Town of Glastonbury

MEMORANDUM

APPLICATION FOR APPROVAL OF 3-LOT SUBDIVISION WITH A SECTION 6.8 REAR LOT SPECIAL PERMIT 256 KNOLLWOOD DRIVE MEETING DATE: APRIL 6, 2021		
PUBLIC HEARING #3 04-6-2021 AGENDA To: Town Plan and Zoning Commission From: Office of Community Development Staff Memo Date: April 1, 2021 Zoning District: Rural Residence (RR) Zone GWP Zone: 2 Applicant: Dutton Associates Owner: Michael Pucci	 EXECUTIVE SUMMARY The applicant is proposing a 3-lot residential subdivision with two rear lots and one frontage lot on 11 acres located off the permanent cul-de-sac at the southern end of Knollwood Drive in the Rural Residence Zone. All three of the lots will be accessed by an approximately 420-foot long, 16-foot wide, shared driveway. The lots will be served by well water and will have an on-site septic systems. A private stormwater detention and water quality basin that will treat runoff for all three lots will be located at the southwestern corner of lot 2. There is a small area of wetlands located at the southwest corner of the site. However, there will not be direct impacts to the wetland only regulated activity within the 100-foot upland review area. All three lots

Aerial View of proposed subdivision. Top—existing lot lines; Bottom—proposed lot lines (approximate)

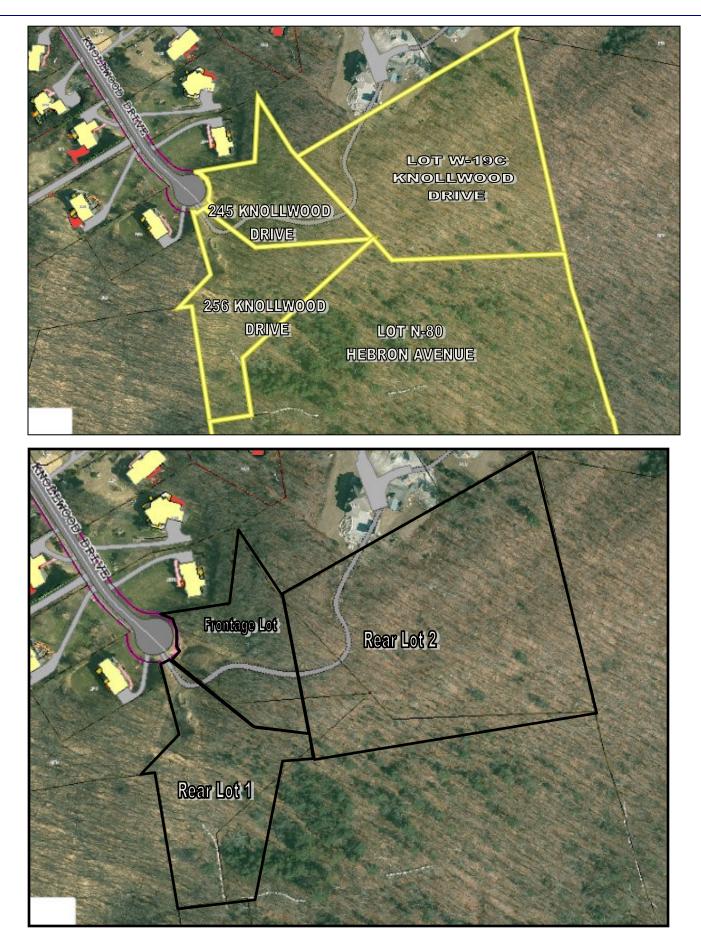
This parcel is surrounded by single-family residential to the north and west and undeveloped land to the south and east.
